Access Assessment Report

Denman Storage Sheds Complex

Reference No: 113411-Access-r 02

Date: 22 April 2021

Figure: Typical parallel accessible carparking space requirements.

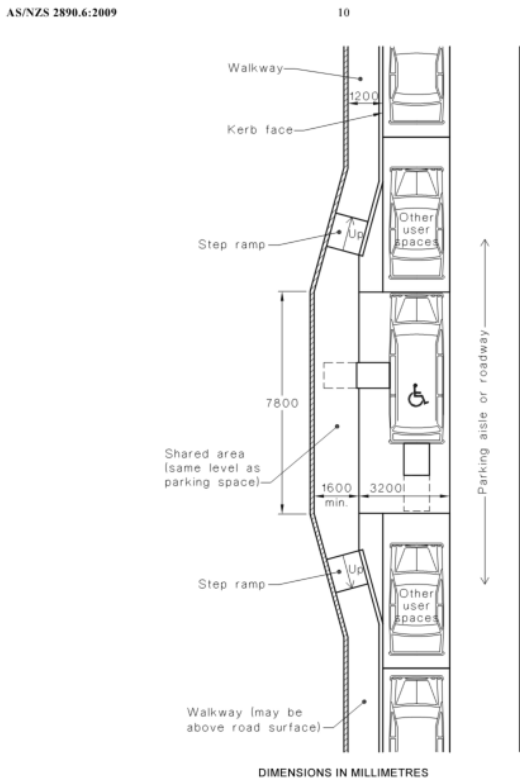
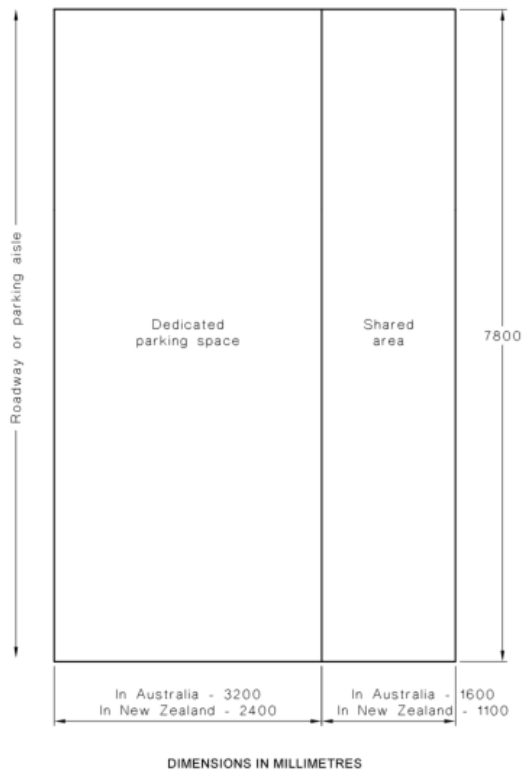
Where an on-site accessible parallel parking space is proposed along the western boundary of the allotment the parking space is to comply with the requirements of AS2890.6-2009 by achieving a minimum length of 7800mm and 3600mm wide. In addition to these dimensions a shared zone for the unloading and loading of a wheelchair is to be provided alongside the space with dimensions of 7800mm long by 1600mm wide. An illustration of such requirements is provided below. The parking space is to be appropriately sign posted to restrict non-disable users from parking in the bay where more than 5 on-site parking spaces are provided. The current dimensions of the proposed accessible space do not comply.
